DOCKETED	
Docket Number:	23-OPT-01
Project Title:	Fountain Wind Project
TN #:	262352-3
Document Title:	Additional Administrative Records for the Fountain Wind Proceeding_Part 3
Description:	N/A
Filer:	Ngoc Tran
Organization:	California Energy Commission
Submitter Role:	Commission Staff
Submission Date:	3/25/2025 3:27:14 PM
Docketed Date:	3/25/2025

TABLE OF CONTENTS

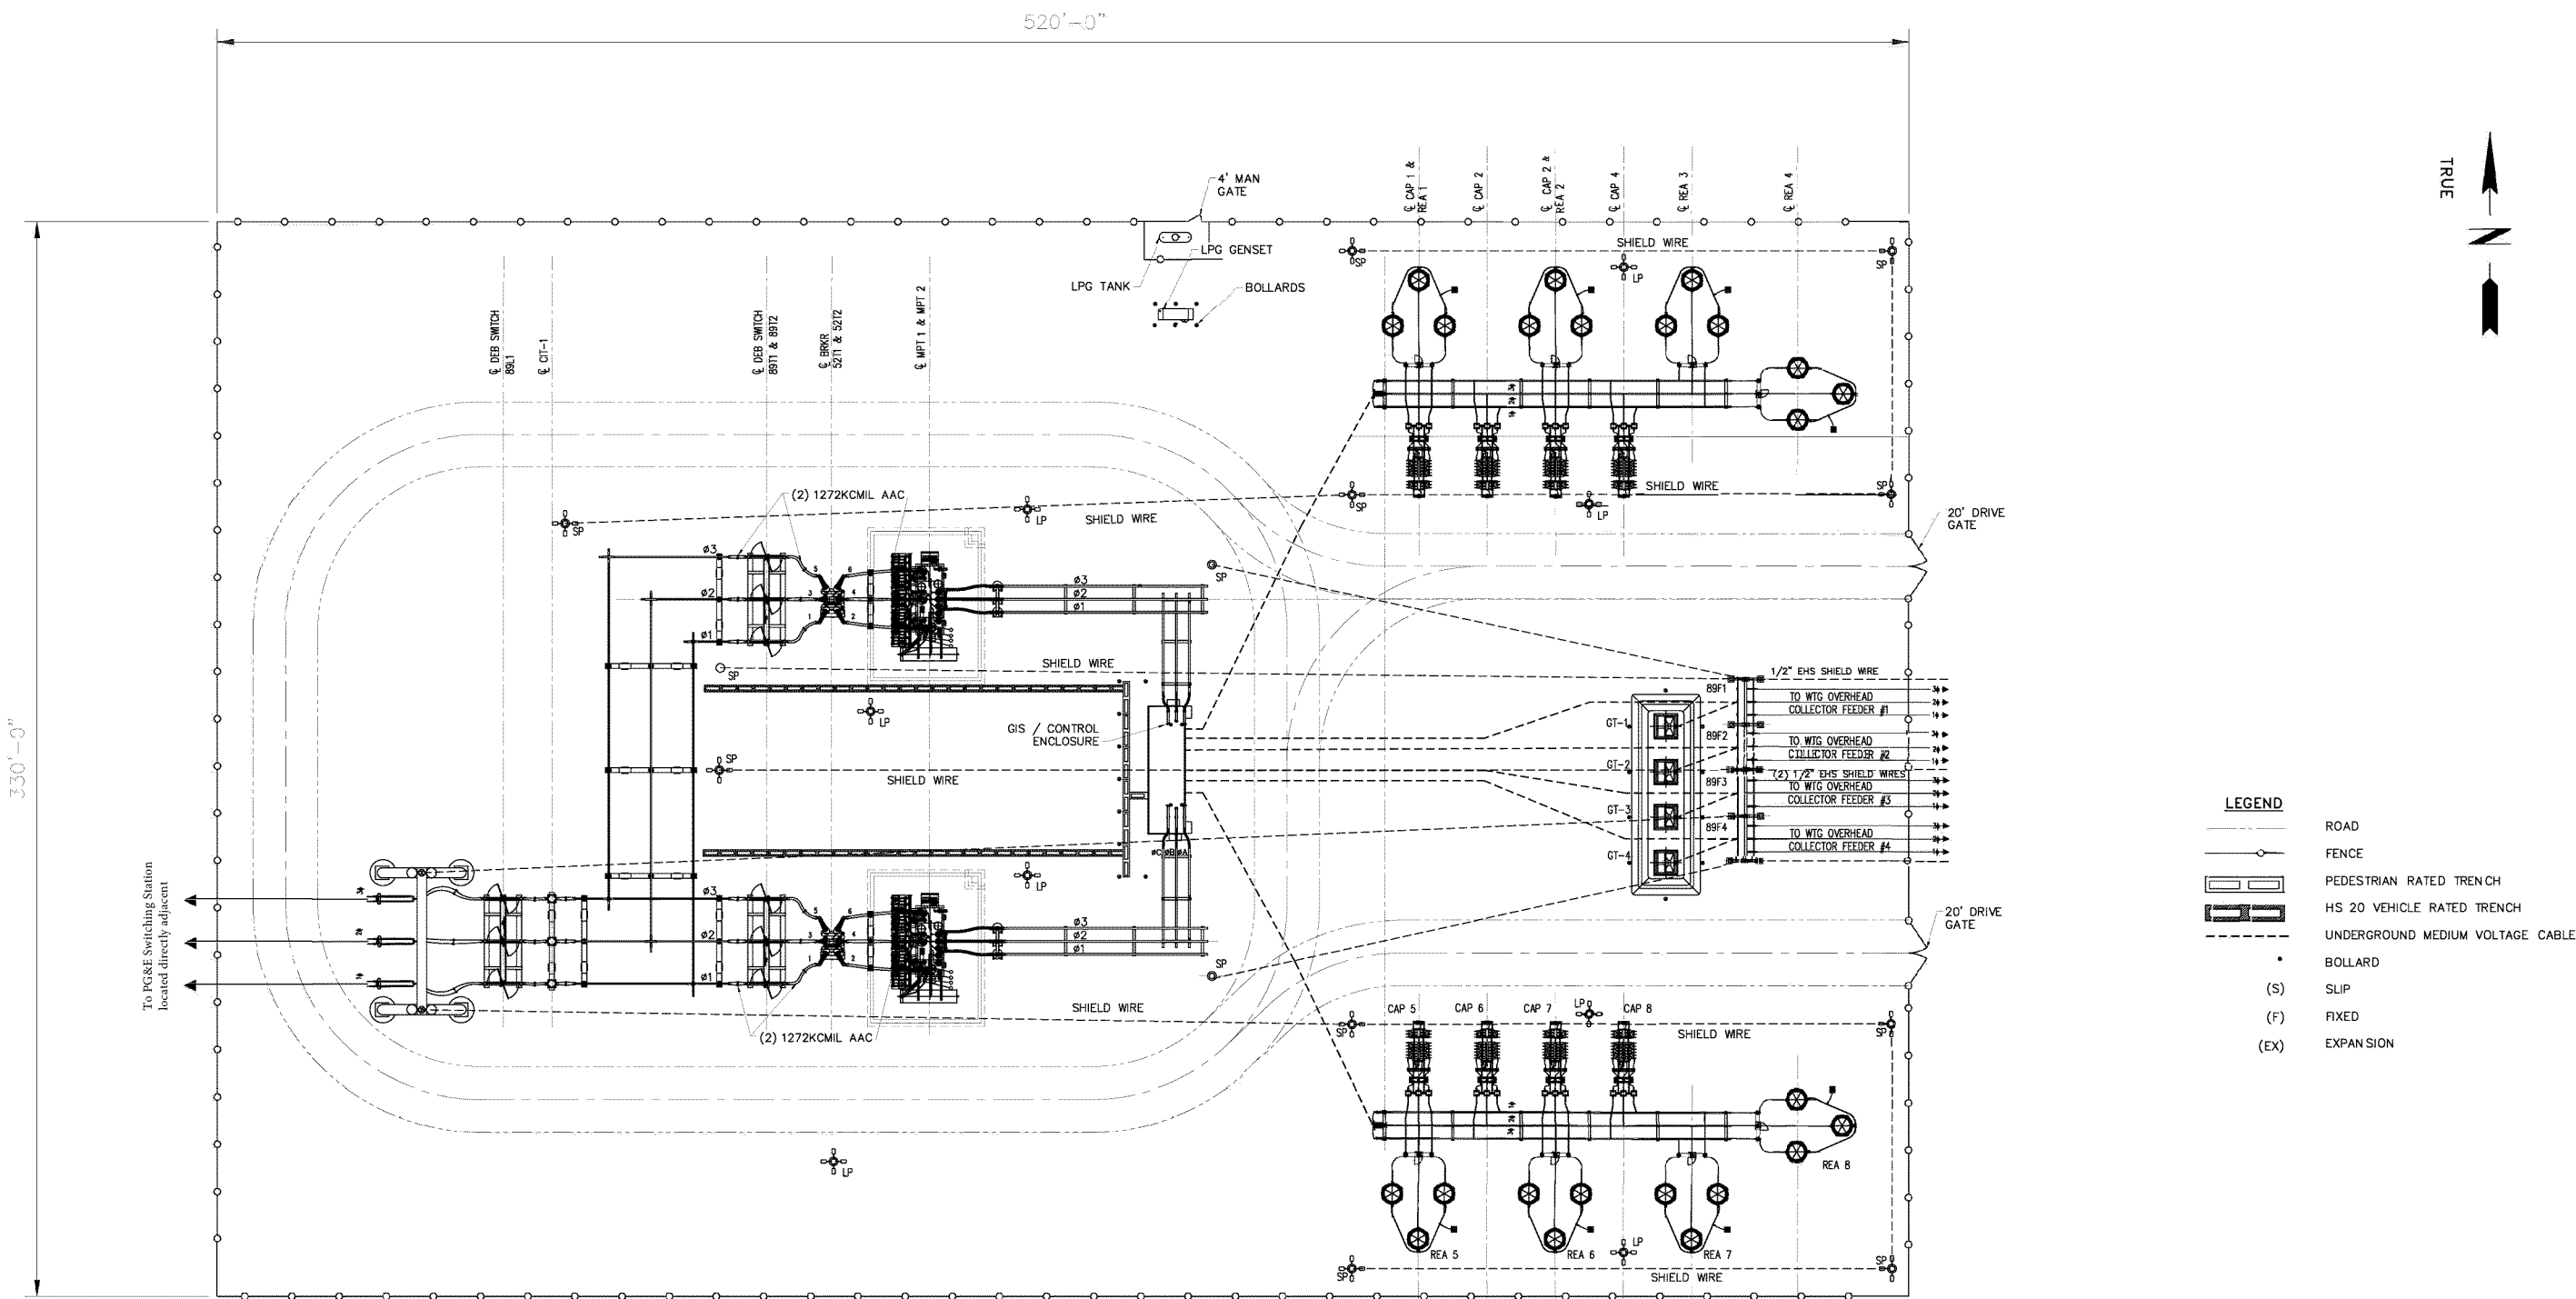
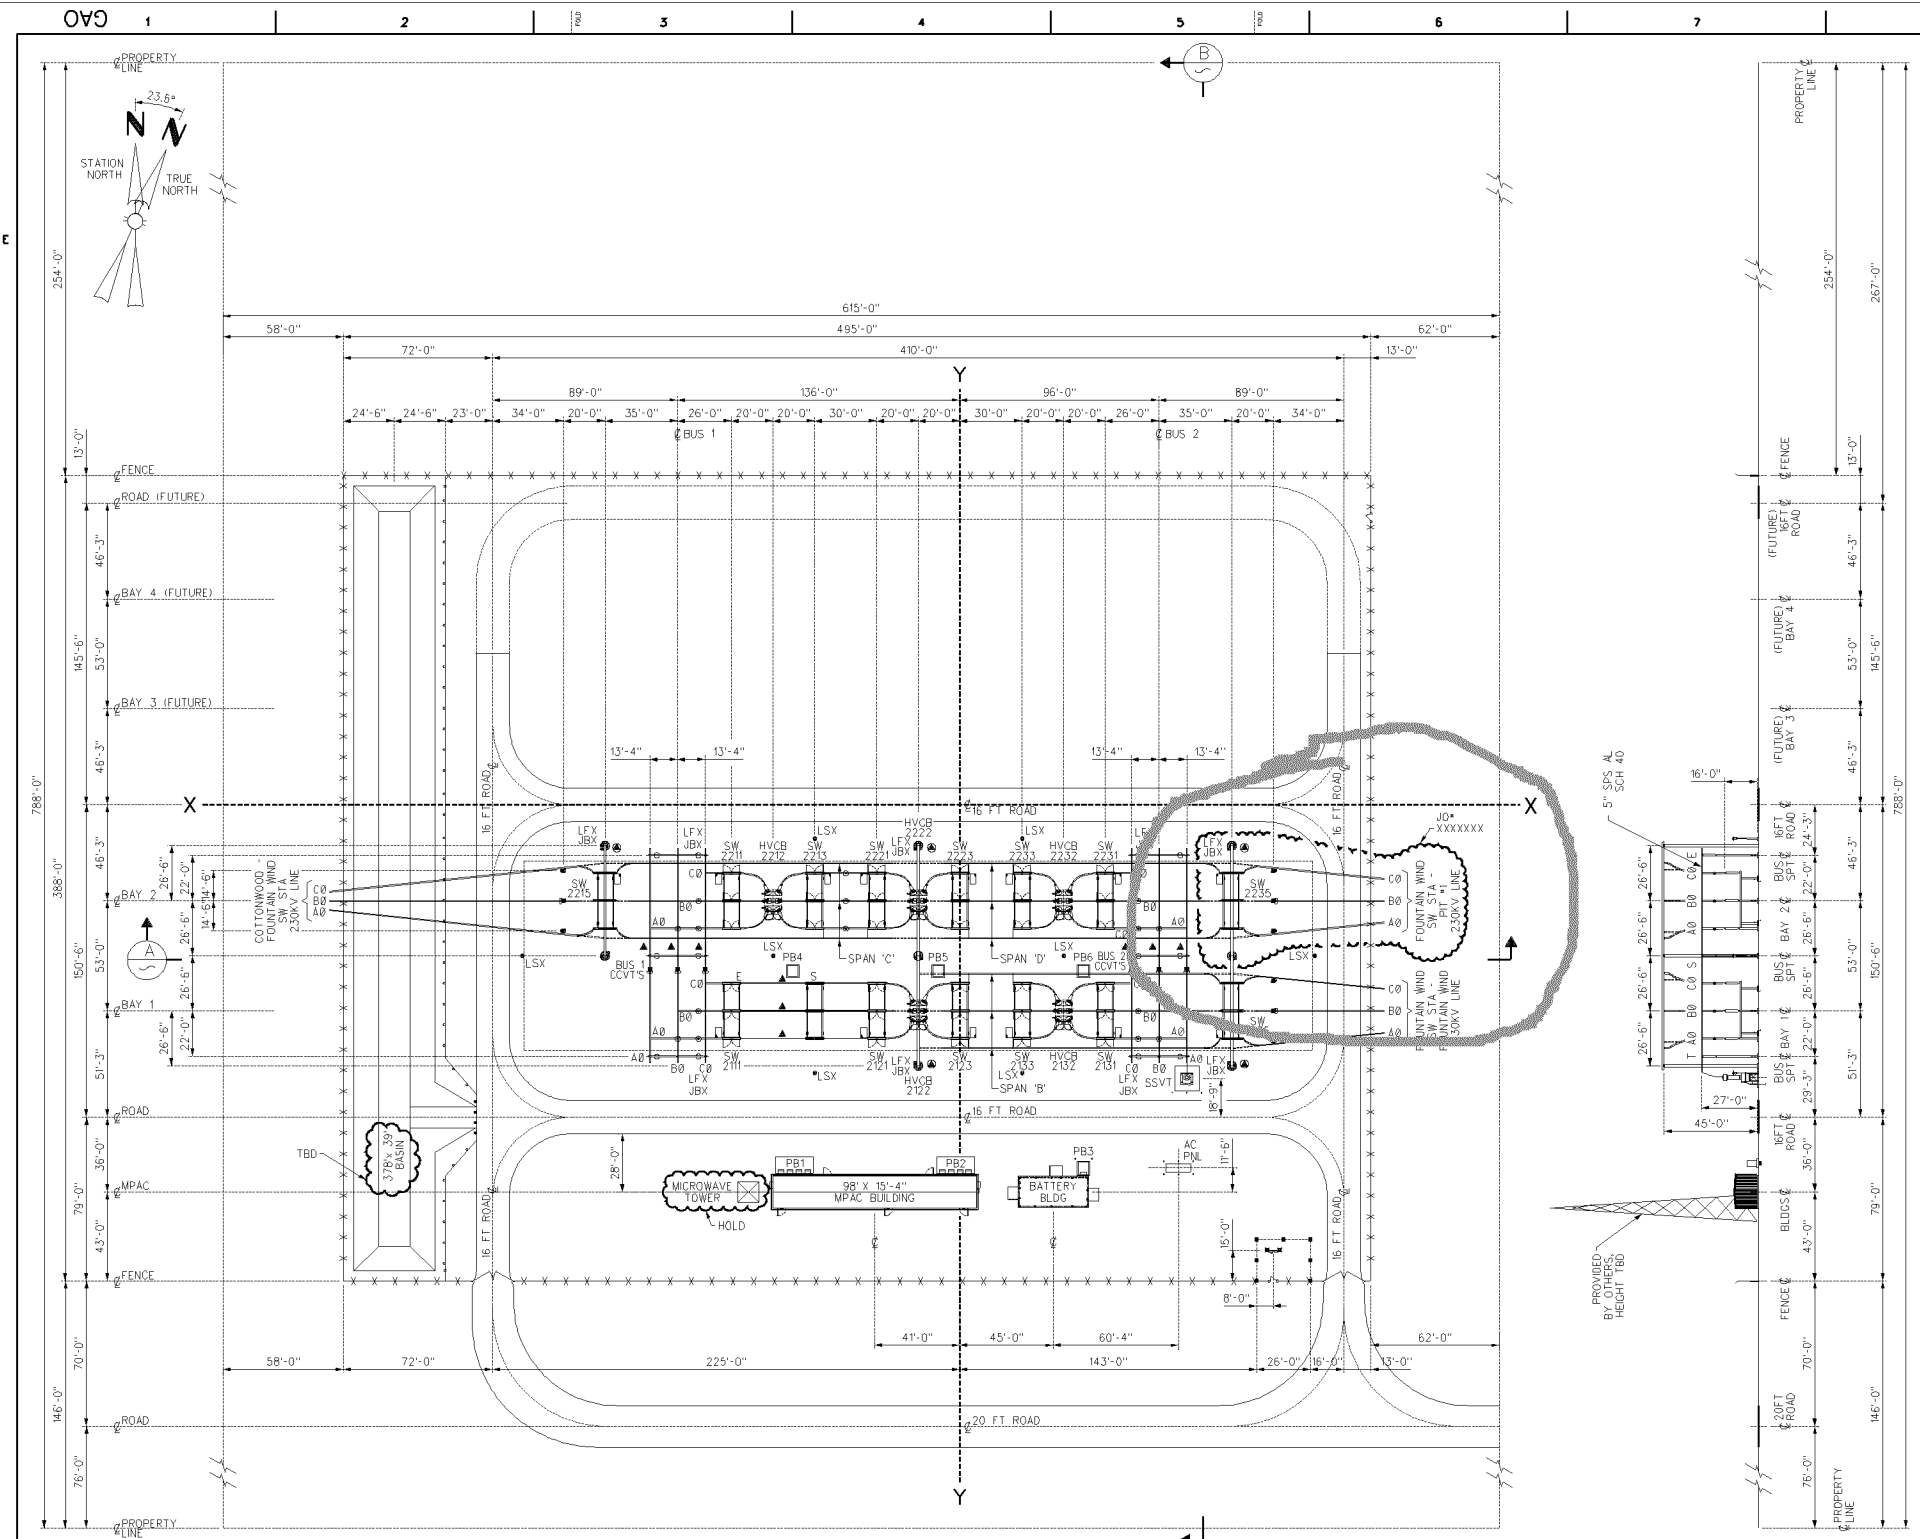
See the highlighted section on the attached page 37 figure. We think it is just an error and something taken from another project, but it raises concerns about the rest of the information in the figure.

The figures provided in TN# 251663 appear to have errors. On page 37, the 11.5 mile-long 230 kV transmission lines would be connected to the BPA Slatt Substation from the Fountain Wind project substation. On page 42, a modification of Fountain Wind SW STA - PIT #1 230 kV line is proposed. We think it is as simple as circling the wrong part of the diagram. If these are errors, please provide corrected figures and provide the 230 kV line rating, conductor type and current carrying capacity of the conductor. Otherwise, provide detailed information and figures of the modification.

The figures provided in TN# 251663 appear to have errors. On page 37, the 11.5 mile-long 230 kV transmission lines would be connected to the BPA Slatt Substation from the Fountain Wind project substation. On page 42, a modification of Fountain Wind SW STA - PIT #1 230 kV line is proposed. We think it is as simple as circling the wrong part of the diagram. If these are errors, please provide corrected figures and provide the 230 kV line rating, conductor type and current carrying capacity of the conductor. Otherwise, provide detailed information and figures of the modification.

Hi Lon, the "bubbling" on the figure on p. 42 indicates "final design pending" for those components.
 On p. 37 this is an error. Please see attached for the updated figure.
